2. 1199 West Central Street

Re: 1199 West Central Street – Garelick Farms
MassDEP File No. 159-1322
Notice of Intent Peer Review #2

FRANKLIN, MA
GARELICK FARMS
FLOODING RESILIENCY IMPROVEMENTS
PERMIT DRAWINGS
SEPTEMBER 2025
REVISED OCTOBER 2025
REVISED DECEMBER 2025
REVISED JANUARY 2026

**EXISTING CONDITIONS AND
SITE PREPARATION PLAN**

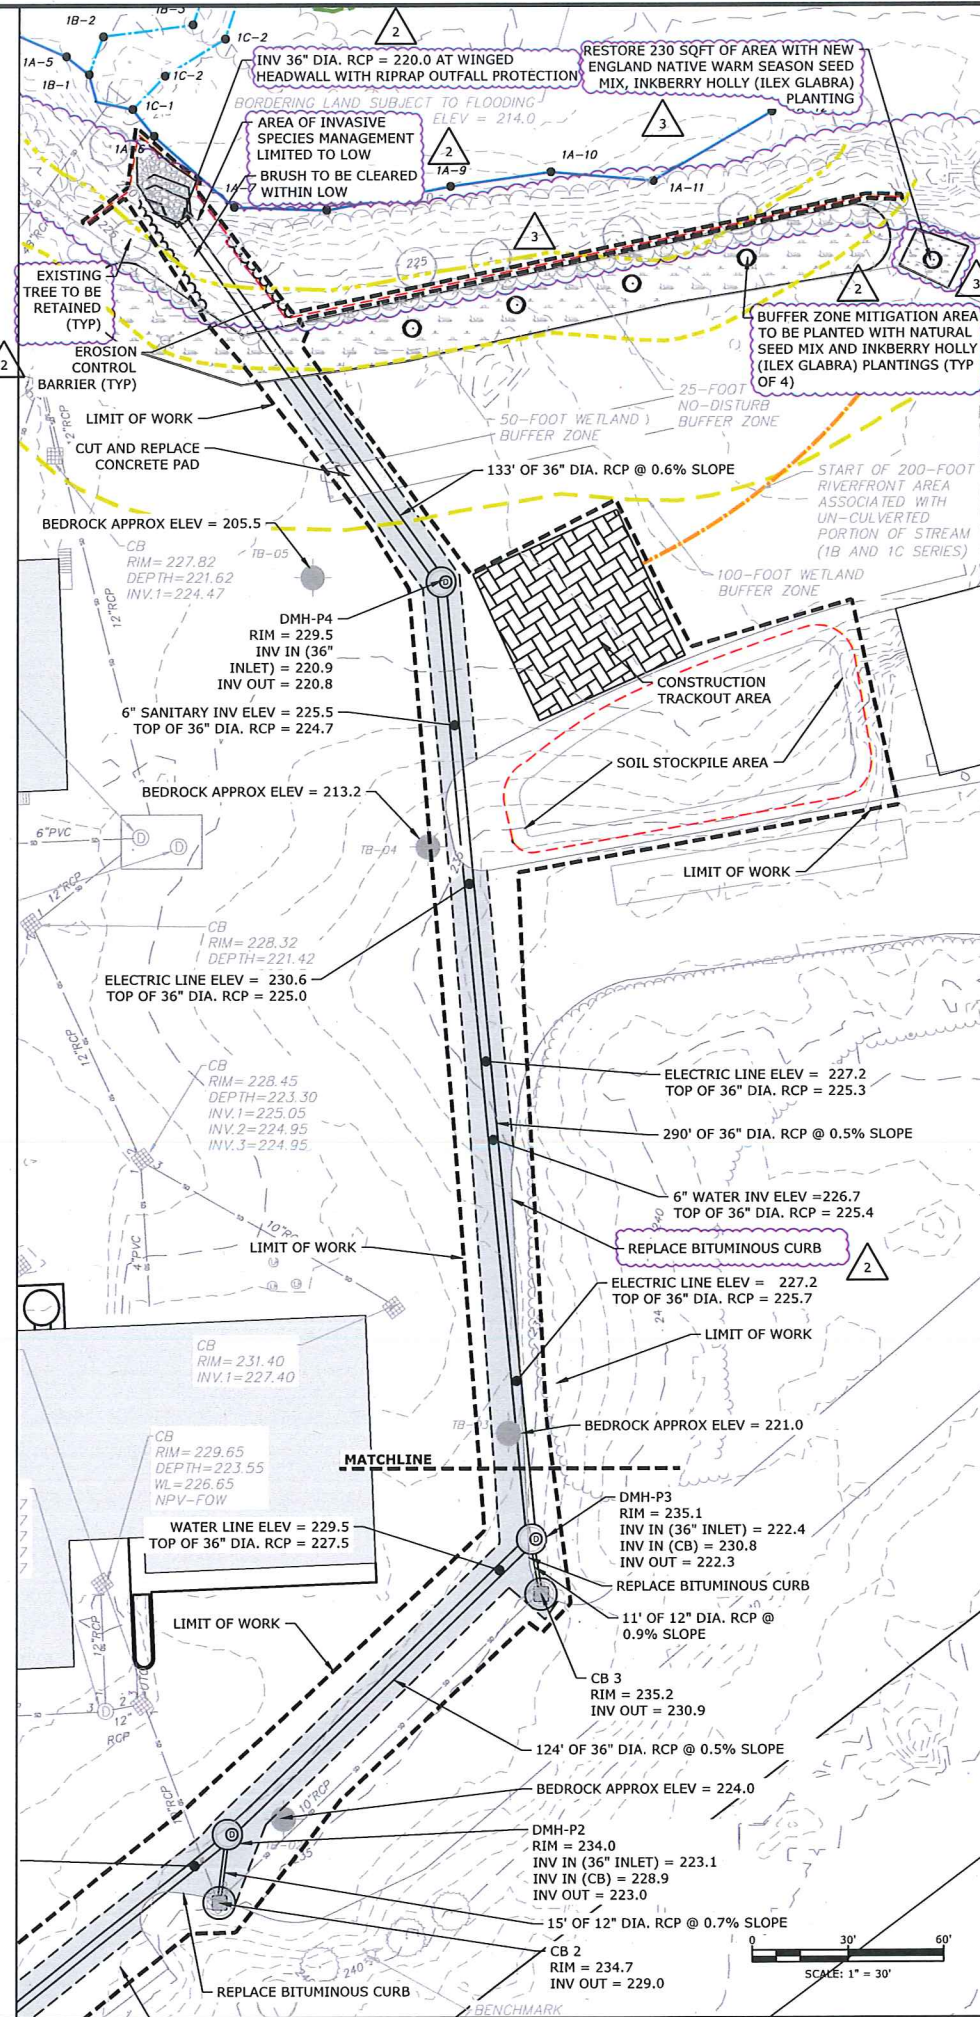
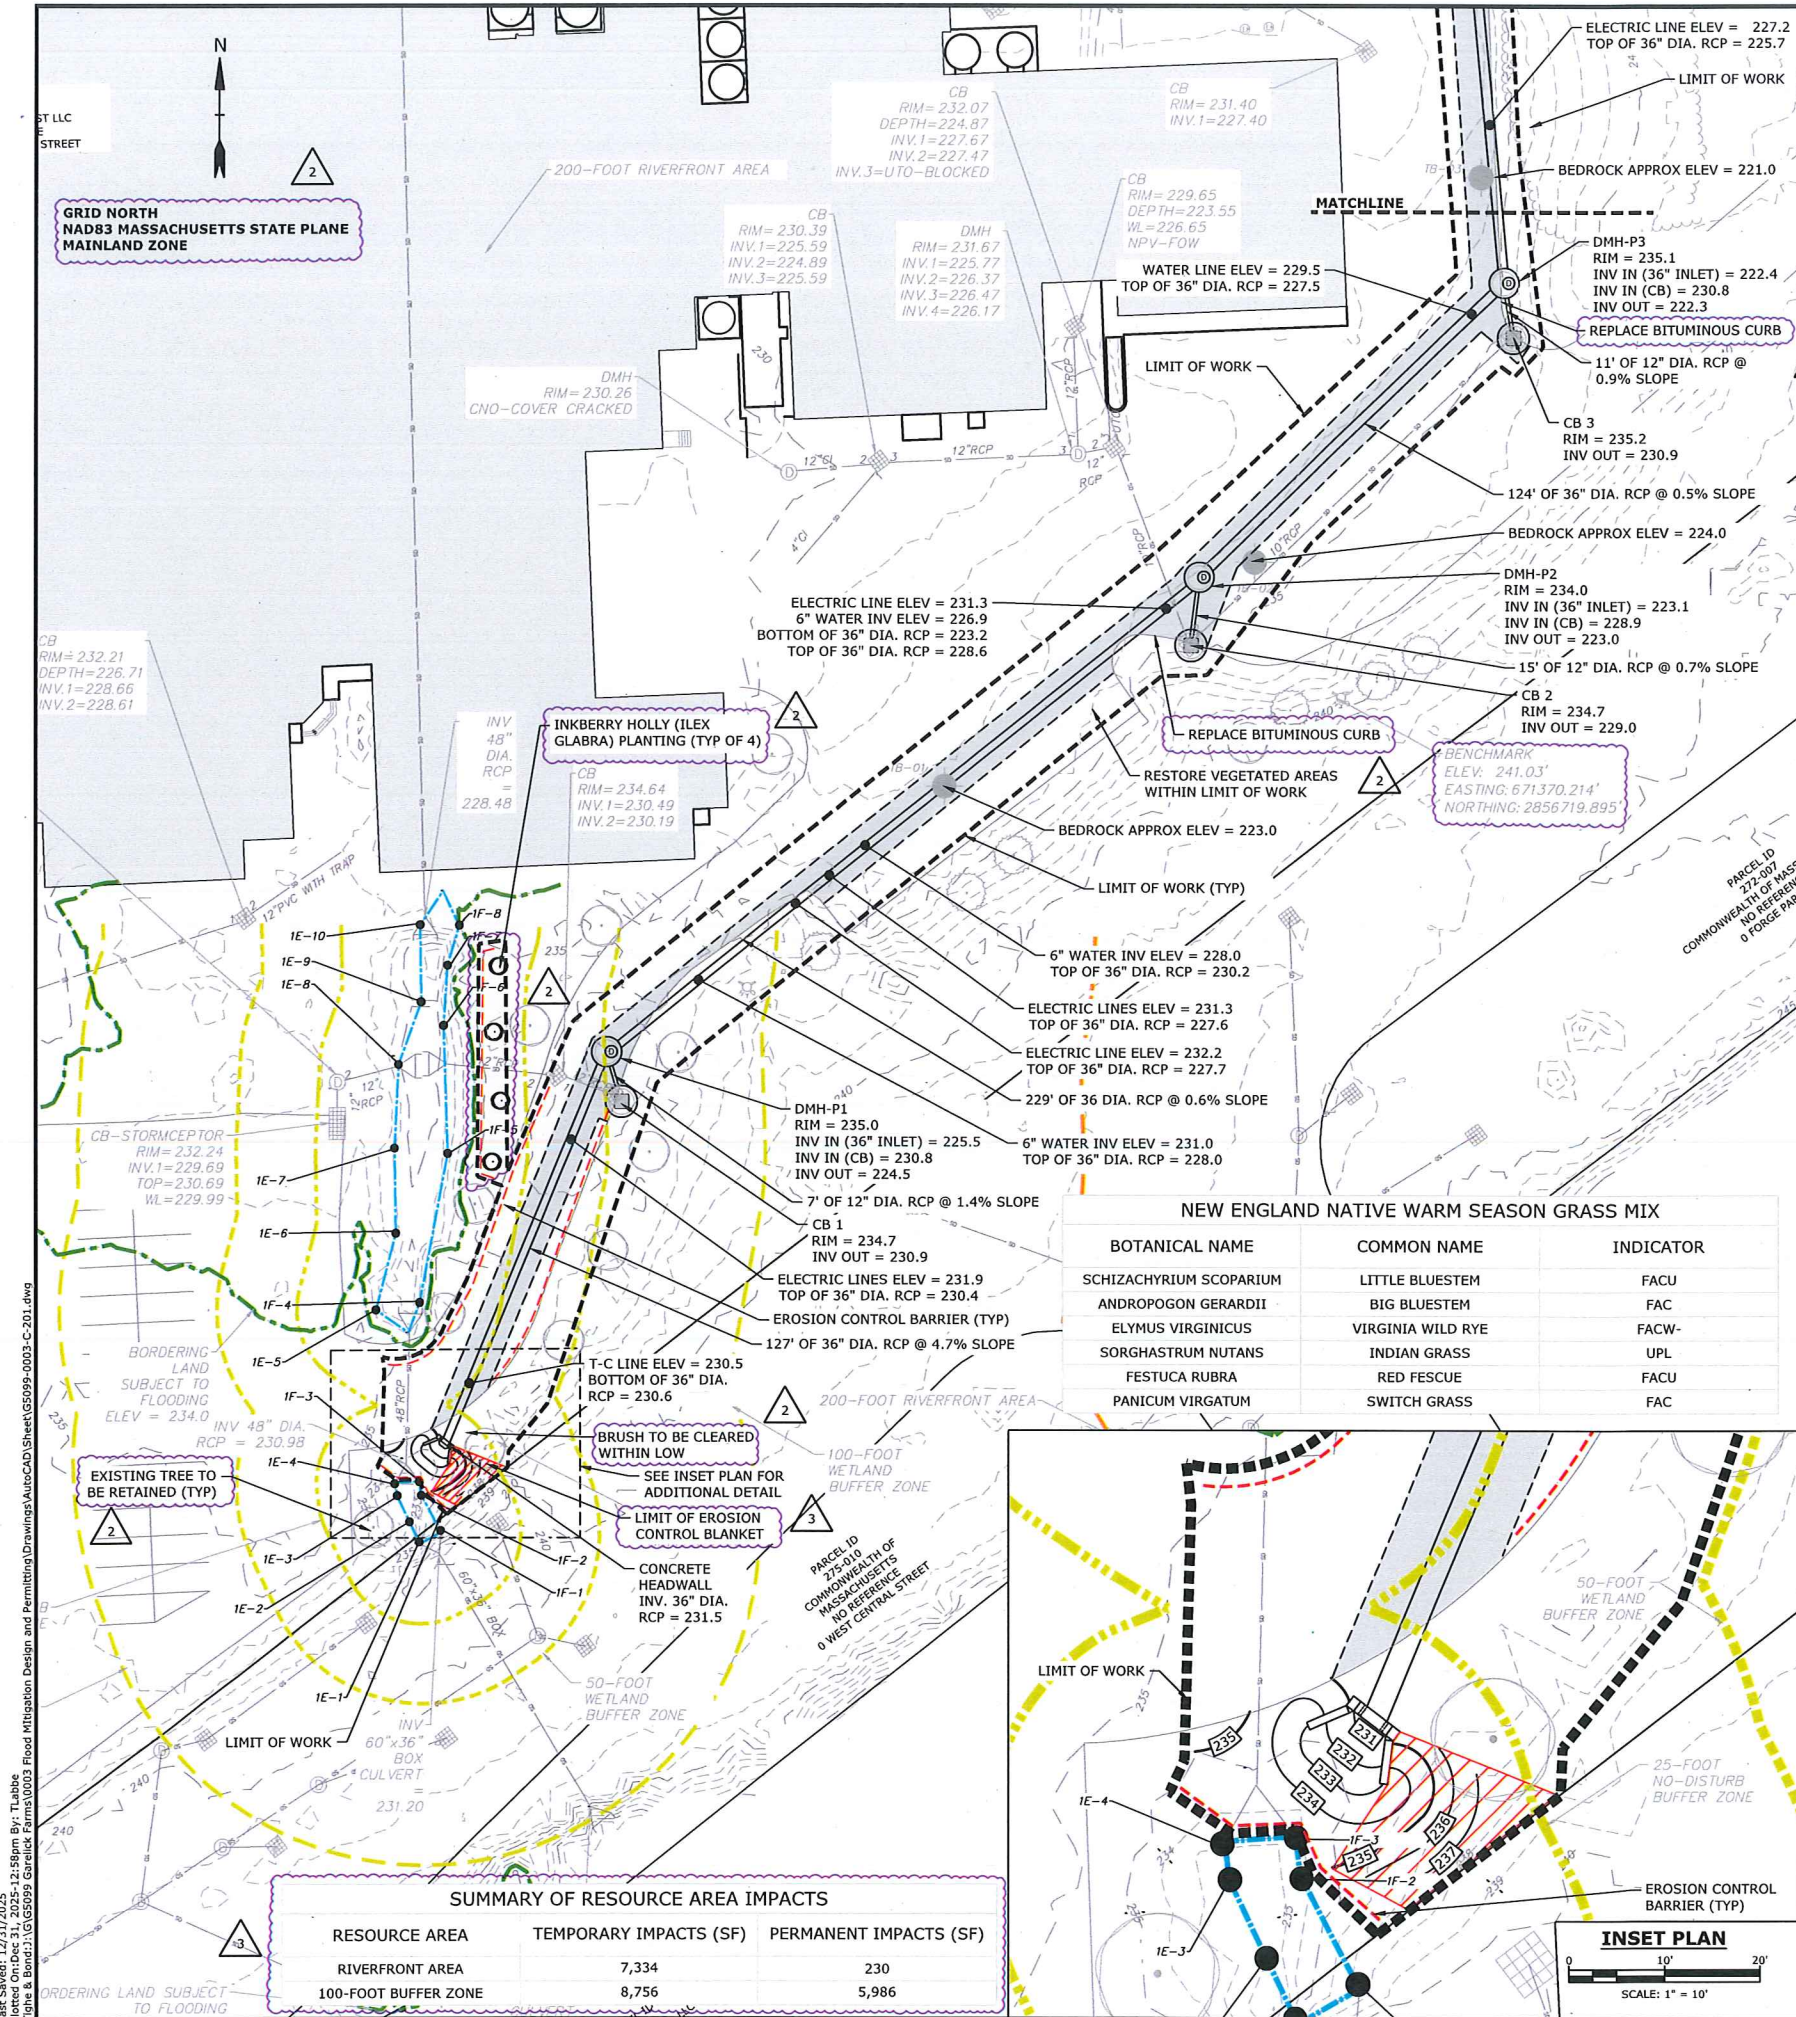
- b. Existing and proposed vegetation referenced in Bylaw Regulation Section 7.18.1.5 and 7.18.1.6 should be included on the plans, including individual trees/shrubs with a diameter greater than 1" proposed for removal. It is BETA's understanding that the Commission generally increases the size threshold for tree location based on the Project and therefore defers to the Commission on this matter. The existing and proposed tree line should be shown, and the proposed trees located along the limits of trenching should be qualified as being either removed or retained.

BETA2: Comment remains. The existing/proposed conditions tree lines are not depicted along the northern portion of the Site adjacent to the 1A Wetland Series where trees are present. The existing conditions plan appears to show a tree line in this area, but it does not encompass the locations of the individual trees that are depicted. The site plans depict a tree line in this area with a proposed conditions line weight, but it does not appear to correlate with the proposed clearing for the headwall. The tree lines should be revised as appropriate.

- W5. The limit of existing pavement and vegetated shoulder should be labeled on the plans adjacent to the location where work is proposed.

TB: Labels have been added to the Site Plans for the limits of existing pavement and vegetative shoulders. See sheet C-102.

T&B2: The existing/proposed tree lines have been added to the project plans in the area of the proposed drainage pipe and outfall installation. A note has been added on sheet C-102 to indicate that brush will be cleared within the limit of work in the area. The proposed condition tree line referred to in BETA's second round review comment appears to be the revision cloud used to indicate changes throughout various iterations of plan sets. To clarify the difference, revision clouds have been changed to purple.

C-501

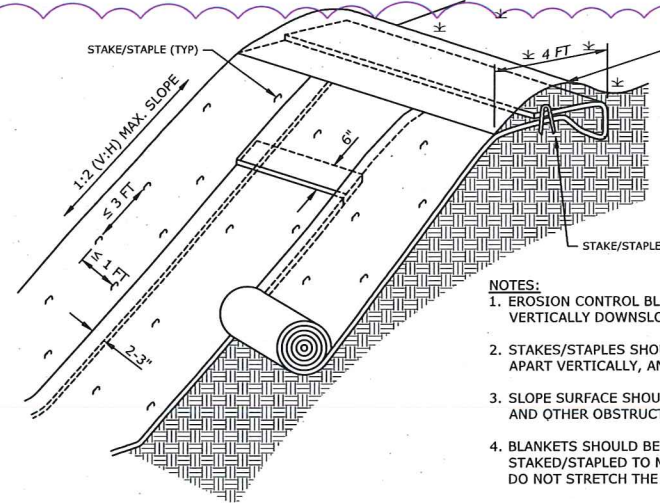
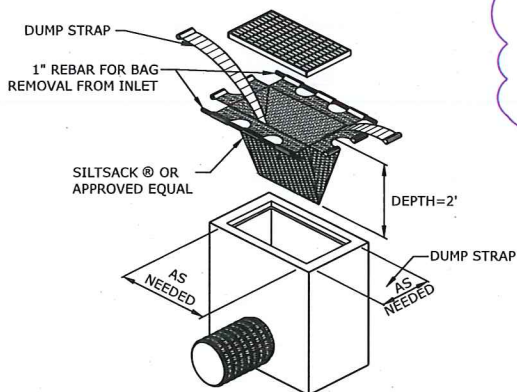
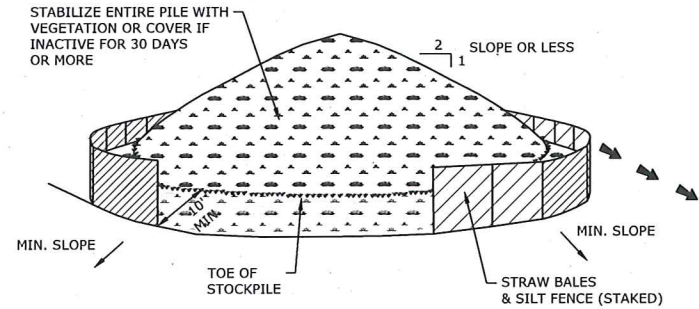
BETA2: BETA defers to the Commission on the approval of the use of straw wattles as erosion controls, as they have discouraged their use in recent years. The use of silt fence and hay/straw bales is referenced within the soil stockpile detail on page C-501 within Section 3.3 of the O&M Plan and should be revised accordingly.

- SW4. Recommend providing a detail for the replacement of curb on site.

TB: A detail for the replacement of curbing has been added to sheet C-501.

T&B2: The detail on sheet C-501 has been revised to indicate the use of compost filter tubes, and the O&M Plan has been updated to remove references to straw wattles.
